Work Order ID 115614

Item Name: Replacement Exterior Window For -111

DRAWING NO. D3290	TITLE REPLACEMENT WINDOW ASSEMBLY	REV. C	DART AEROSPACE LTD ENGINEERING ORDER		D.E.O. NO. D3290-C-1	SHEET NO. SHEET 1 OF 1	SCALE NTS
DRAWN <i>GP</i>	CHECKED <i>ls</i>	MFG. APPR. <i>FE</i>	APPROVED <i>MD</i>		DE APPR. <i>##</i>		
DATE 09.09.18	DATE 09.09.18	DATE 09.09.18	DATE 09/09/21		DATE 09/09/21

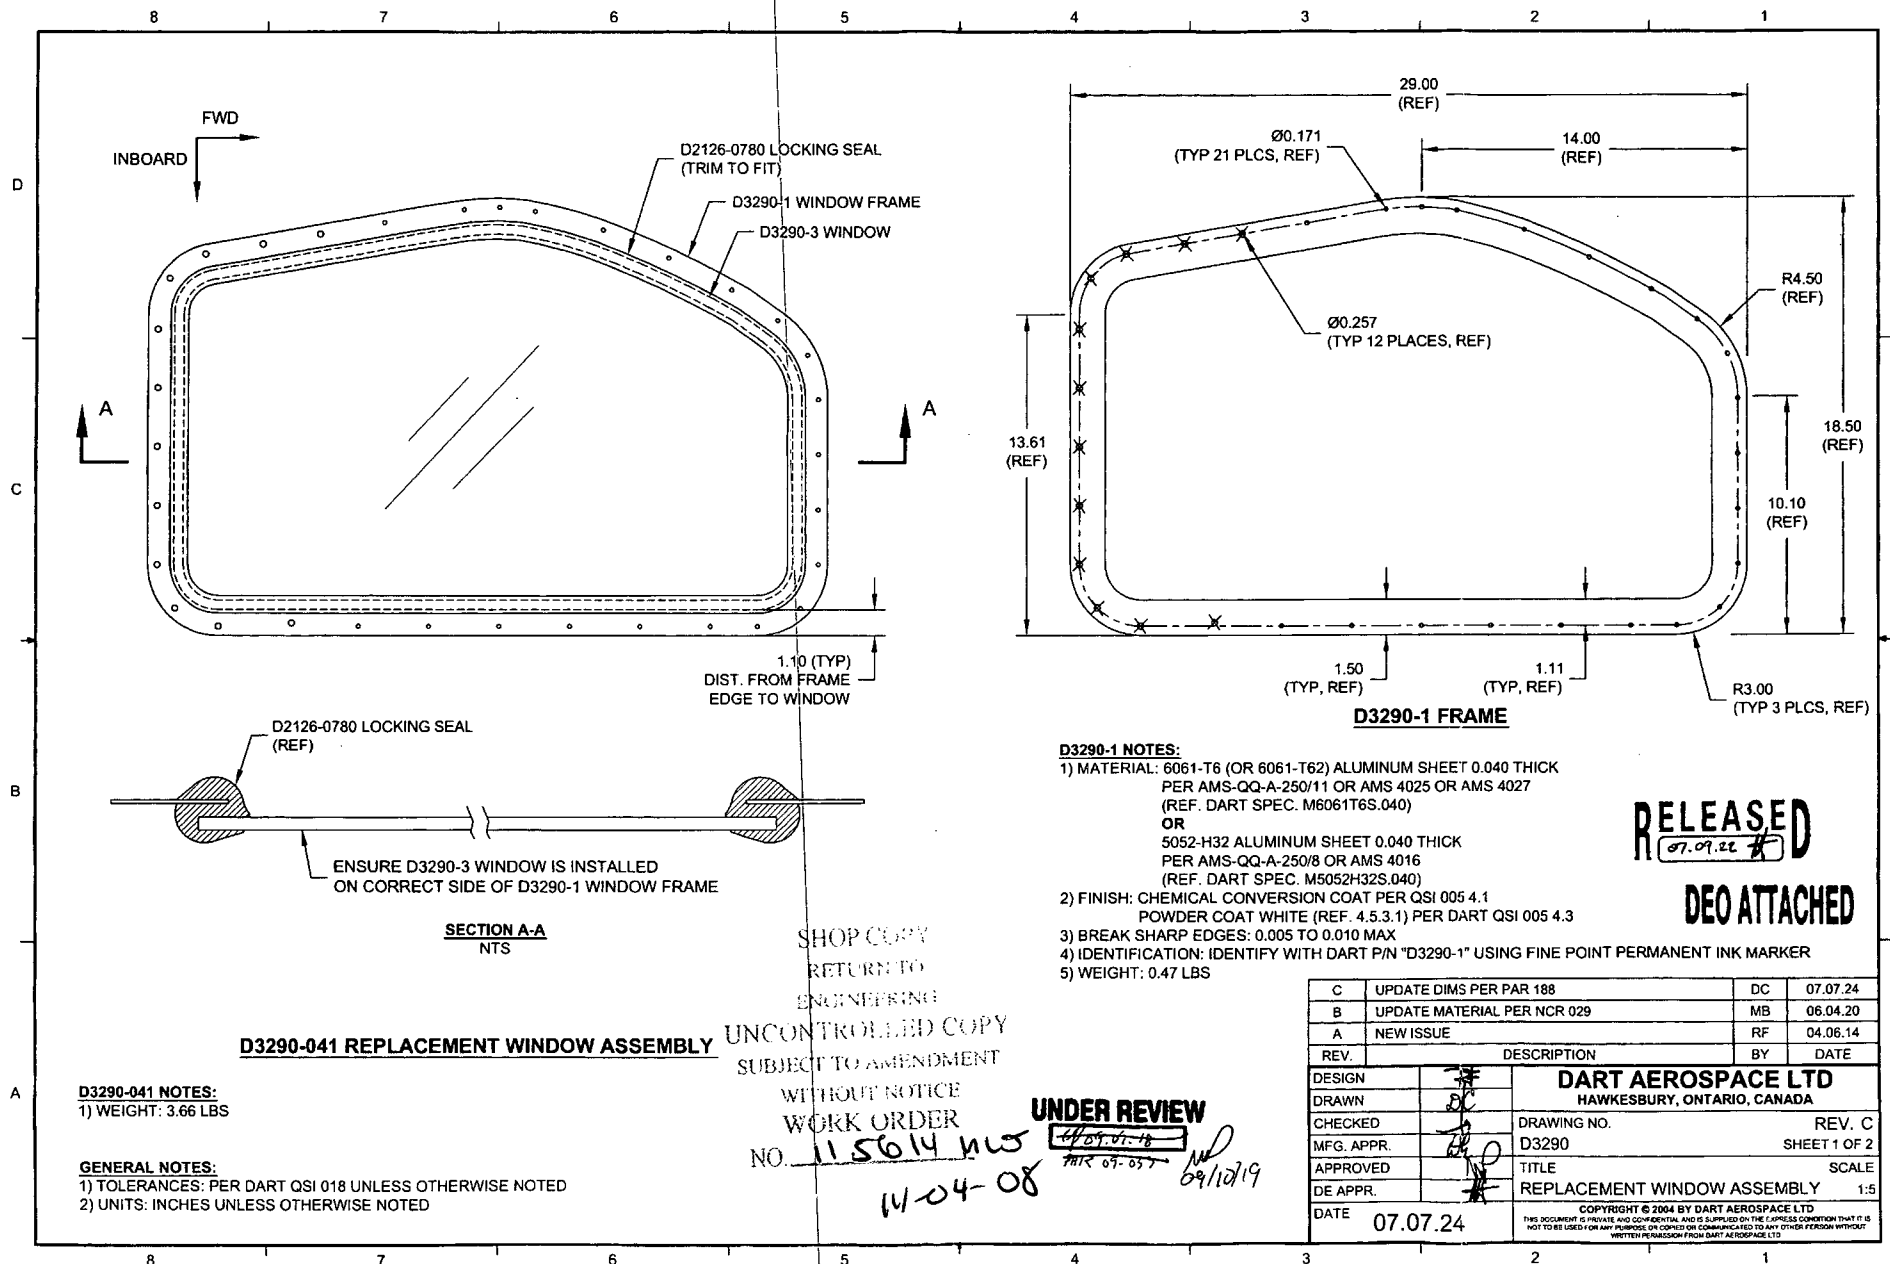
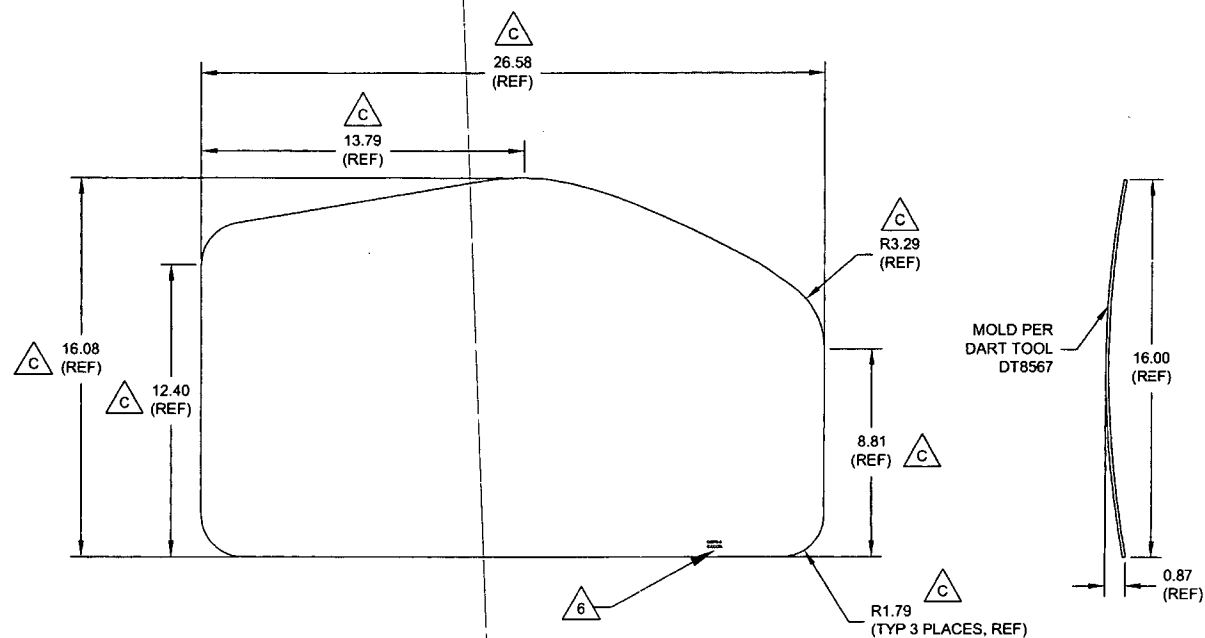
CHANGE MATERIAL THICKNESS OF D3290-1 FRAME TO 0.063 FROM 0.040. REF PAR 09-033.

MATERIAL CALL-OUT OF D3290-1 FRAME ON SHEET 1 IS AMENDED AS FOLLOWS:

- 1) MATERIAL: 6061-T6 (OR 6061-T62) ALUMINUM SHEET ~~0.040 THICK~~ 0.063 THICK (REPLACE)
 PER AMS-QQ-A-250/11 OR AMS 4025 OR AMS 4027
~~(REF. DART SPEC. M6061T6S.040)~~ REF. DART SPEC. M6061T6S.063 (REPLACE)
 OR
 5052-H32 ALUMINUM SHEET ~~0.040 THICK~~ 0.063 THICK (REPLACE)
 PER AMS-QQ-A-250/8 OR AMS 4016
~~(REF. DART SPEC. M5052H32S.040)~~ REF. DART SPEC. M5052H32S.063 (REPLACE)
